P 534054

## ON-SITE SEWAGE DISPOSAL SYSTEM TANK REPLACEMENT HOWARD COUNTY HEALTH DEPARTMENT BUREAU OF ENVIRONMENTAL HEALTH

SUBDIVISION: TRIADELPHIA FARMS II LOT NUMBER: 11-B

ADDRESS: 13388 HUNT RIDGE ROAD PROPERTY OWNER: KANG CHUL

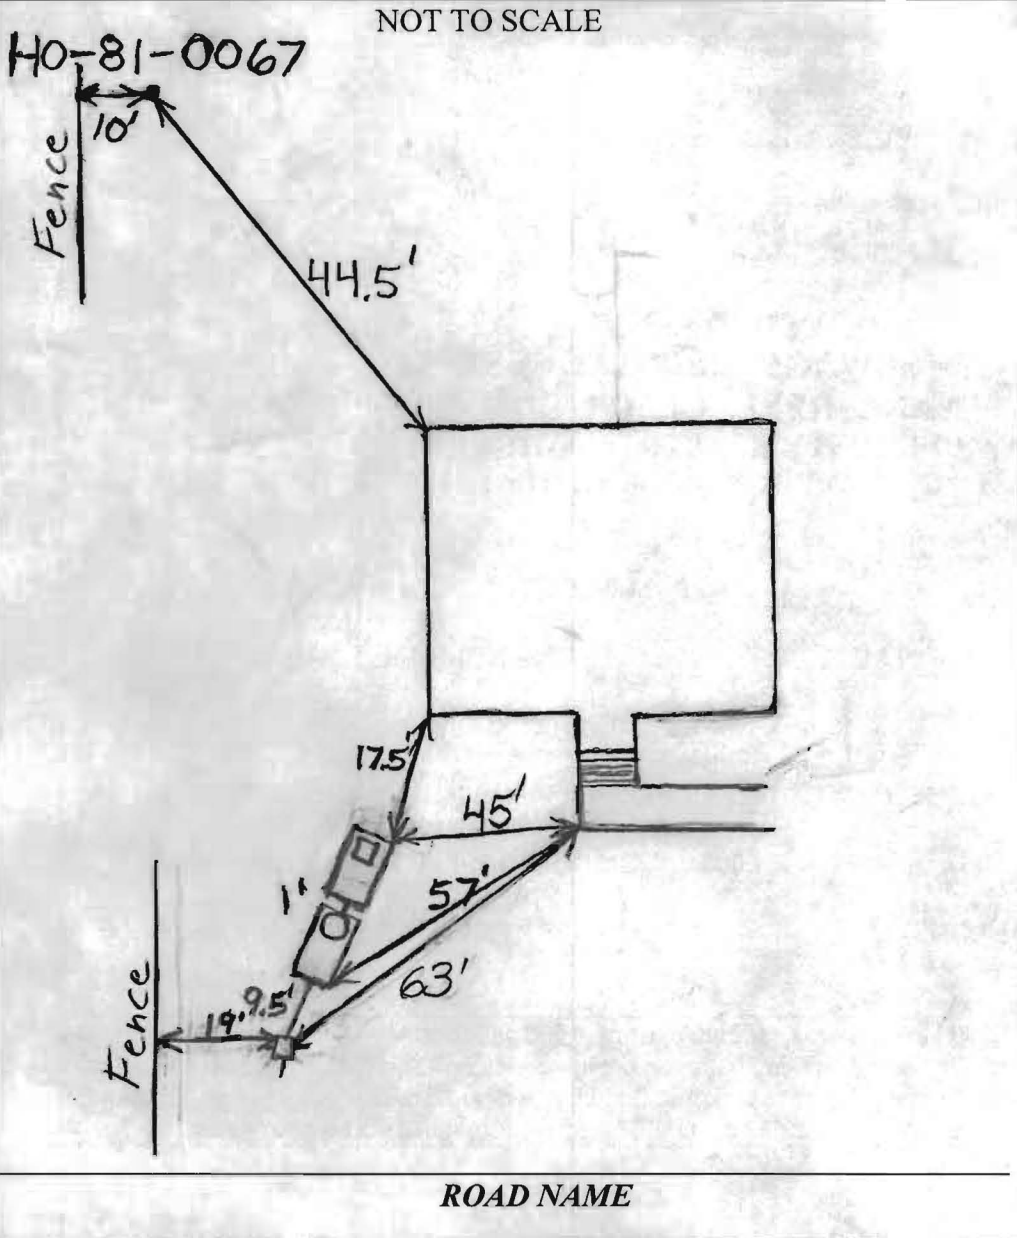
PRE-CONSTRUCTION: 10/7/2010 Tank set. Pipe from original tank to dist. box was going uphill. I told installer to raise tank and line from house or if possible lower dist. box. (BB)

INSTALLATION: 10/8/2010 Installer said he was able to lower pipes going to bed and thus lower dist. box. Slight fall to dist. box. from tank. O.K. to cover. (BB)
